FDPA 86-L-073-03

FINAL DEVELOPMENT PLAN AMENDMENT

ISLAND CREEK

FAIRFAX COUNTY, VIRGINIA

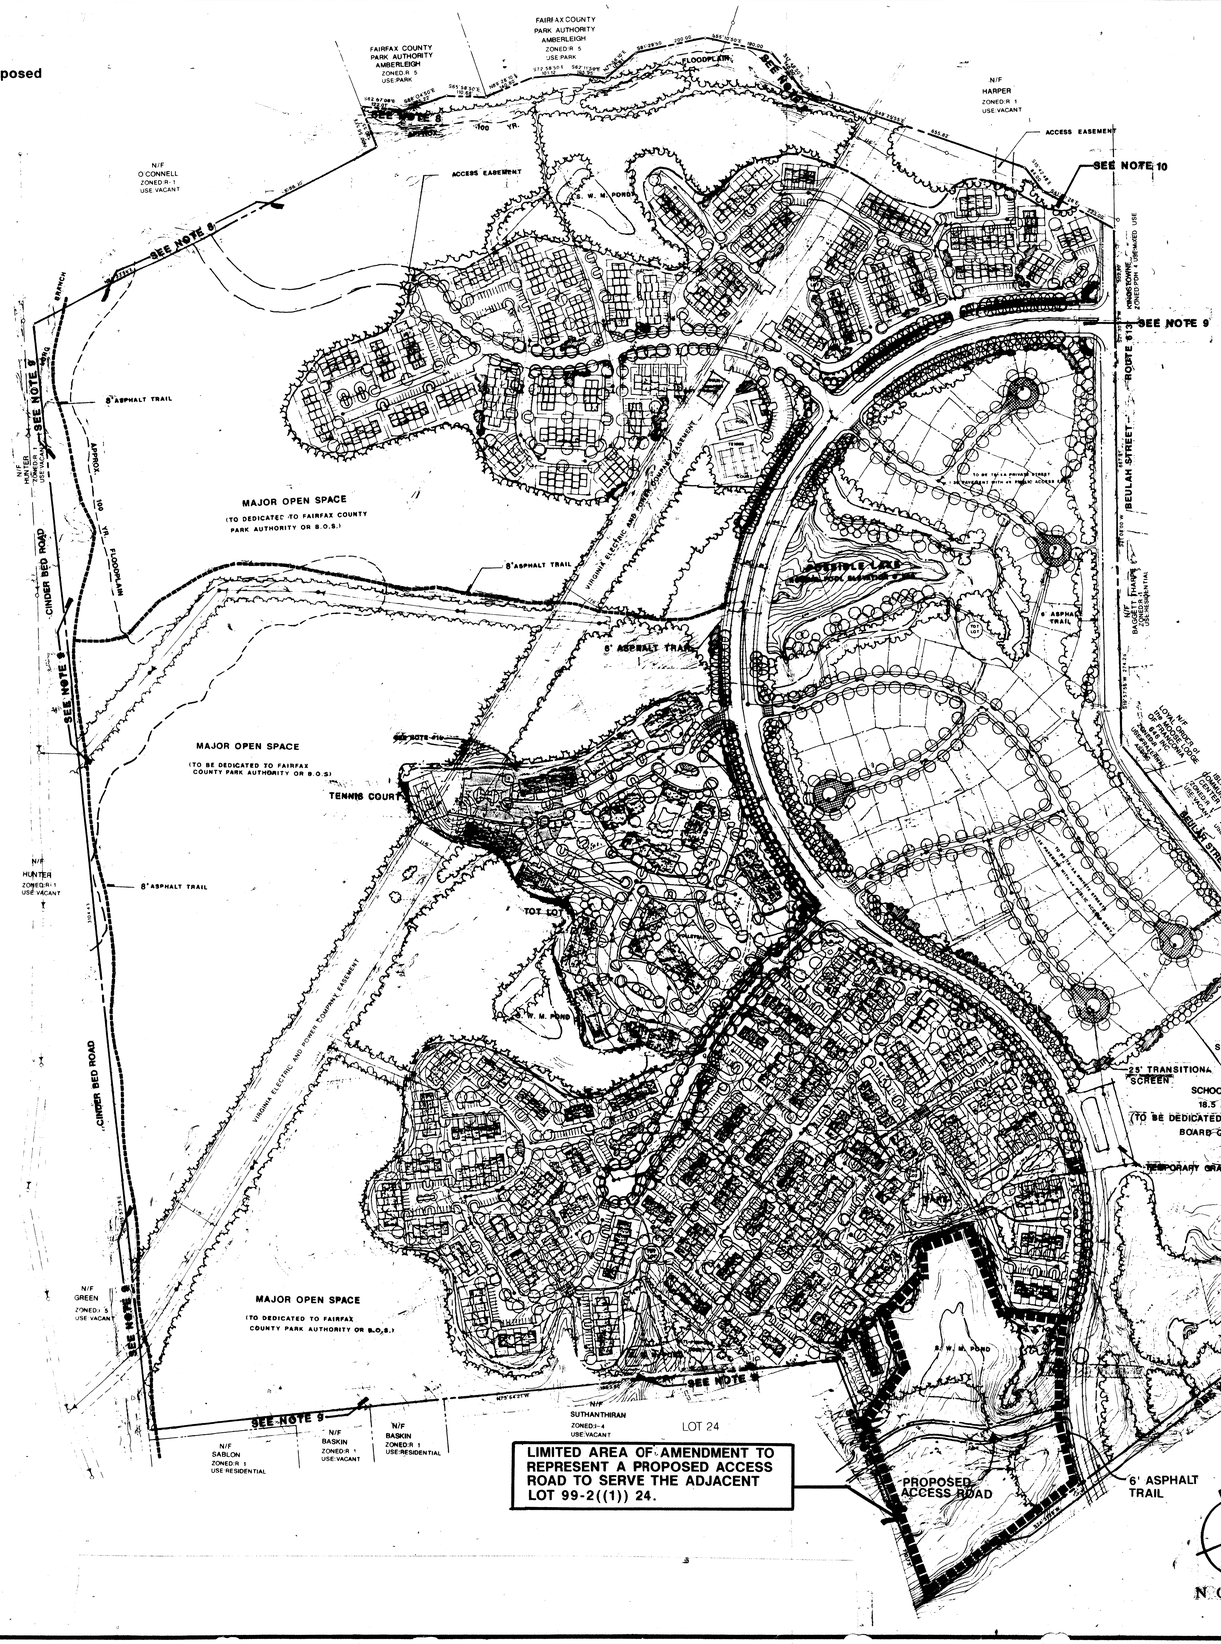
LIMITED AREA OF AMENDMENT TO REPRESENT A PROPOSED ACCESS ROAD TO SERVE THE ADJACENT LOT 99-2((1)) 24.

THIS GRAPHIC IS A COMPOSITE OF PORTIONS OF SHEETS 4 AND 5 OF THE CURRENTLY APPROVED FINAL DEVELOPMENT PLAN. IT INCLUDES THE LIMITED AREA OF THE AMENDMENT THAT HAS BEEN FILED TO REPRESENT A PROPOSED ACCESS ROAD TO SERVE THE ADJACENT LOT 99-2 ((1)) 24.

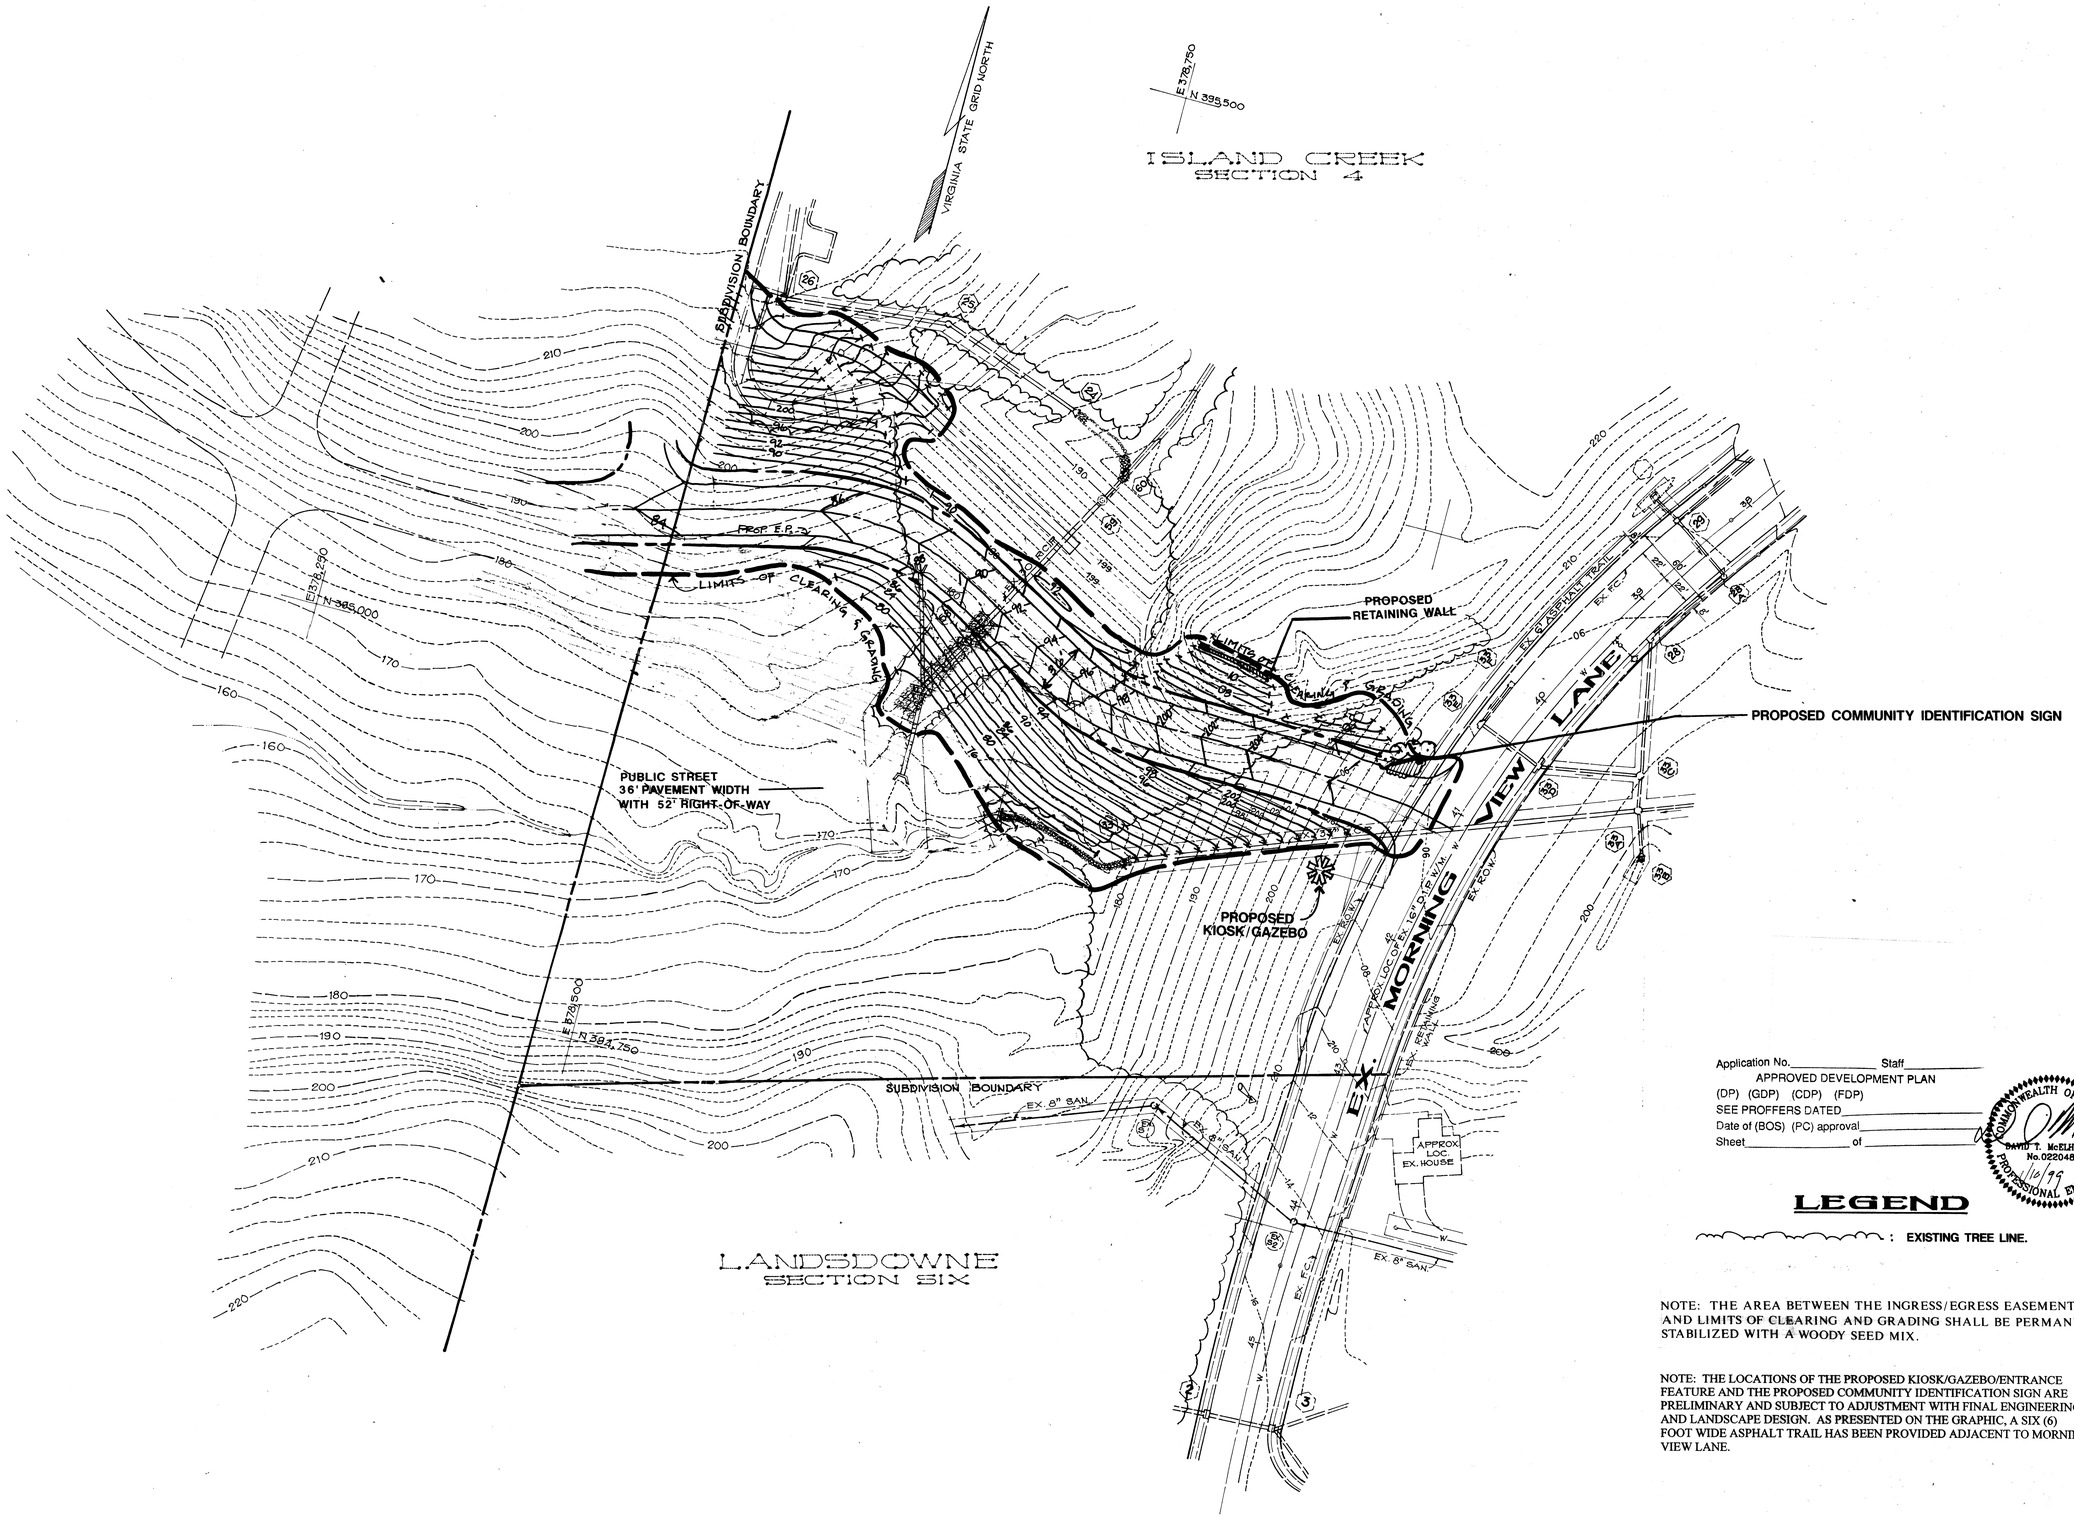
3. THE SOLE PURPOSE OF THE FDPA IS TO REPRESENT A PROPOSED ACCESS ROAD TO SERVE THE ADJACENT LOT 99-2 ((1)) 24.

6. THE ONLY IMPLICATION TO THE APPROVED DEVELOPMENT PROGRAM OF ISLAND CREEK THAT THE PROPOSED AMENDMENT COULD HAVE WOULD BE A SLIGHT REDUCTION OF OPEN SPACE. BASED ON THE APPROVED FINAL DEVELOPMENT PLAN, OPEN SPACE TO BE PROVIDED IS REPRESENTED AT 50±% OR 131 ACRES. BASED ON A REVIEW OF A CUMULATIVE TABULATION PRESENTED ON SP1611 FOR SECTION THREE OF ISLAND CREEK THAT WAS PREPARED IN NOVEMBER 1993, THE CUMULATIVE OPEN SPACE LAND AREA FOR ISLAND CREEK WAS 167.74 ACRES. CONSEQUENTLY, THE PROPOSED AMENDMENT WILL NOT AFFECT THE 50% OPEN SPACE REPRESENTATION ON THE CURRENTLY APPROVED FDP.

LIMITED AREA OF AMENDMENT TO REPRESENT A PROPOSED ACCESS ROAD TO SERVE THE ADJACENT LOT 99-2((1)) 24.
